Access Compliance Report

Public Rights-of-Way

(Curb Ramps)

Intersection ID: 52589	Main Street: BURNETTE_AV	Cross Street: TRIUMPH_DR	Location: W
ADA ID: A544B3BF85E7	Ramp Type: Perp	Initial Pass/Fail: Fail	Overall Compliance: No
Severity Score: 12.5			
Codes/Mitigation Info/Possible Solution		Field Measurements/Component Compliance

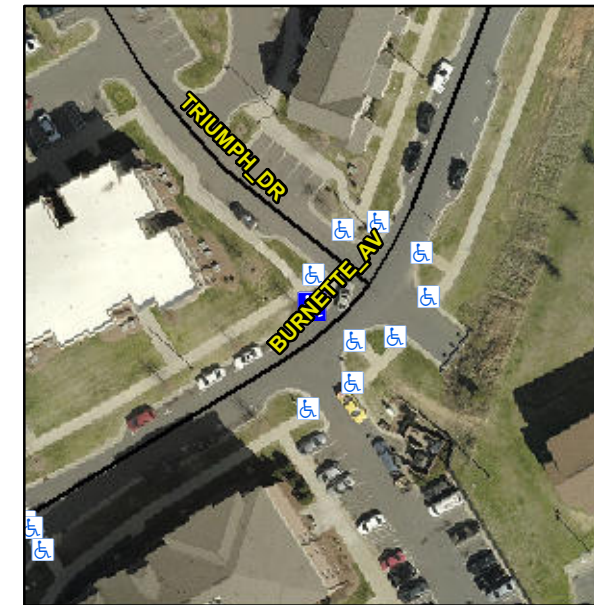
Not Found, R304.2.2

Compliance	Description	Data	Compliance	Description	Data
N/A	Ramp Length (in)	73.0	No	Ramp Slope (%)	8.5
Yes	Ramp Width (in)	71.0	Yes	Ramp XSlope (%)	1.5
N/A	Flare Type LT	N/A	N/A	Flare Type RT	N/A
N/A	Flare Slope LT (%)	N/A	N/A	Flare Slope RT (%)	N/A
N/A	Flare Traversable LT?	N/A	N/A	Flare Traversable RT?	N/A
N/A	Landing Length (in)	N/A	N/A	DWS Provided?	N/A
N/A	Landing Width (in)	N/A	N/A	DWS Contrast?	N/A
N/A	Landing Slope (%)	N/A	N/A	DWS Length (in)	N/A
N/A	Landing X Slope (%)	N/A	N/A	DWS Full Width?	N/A
N/A	Landing Curb? (Y/N)	N/A	N/A	DWS Offset (in)	N/A
N/A	Shared Landing?	N/A			
N/A	Gutter Ponding?	N/A	N/A	Gutter Slope (%)	N/A
N/A	Gutter Lip Ht (in)	N/A	N/A	Gutter X Slope (%)	N/A
N/A	Painted X Walk1?	No	N/A	Painted X Walk2?	N/A
	X Walk 1 Direction	To SE		X Walk 2 Direction	N/A
N/A	X Walk 1 Width (in)	N/A	N/A	X Walk 2 Width (in)	N/A
	X Walk 1 Slope (%)	3.0		X Walk 2 Slope (%)	N/A
	X Walk 1 X Slope (%)	2.2		X Walk 2 X Slope (%)	N/A

Remove & Replace Entire Ramp.
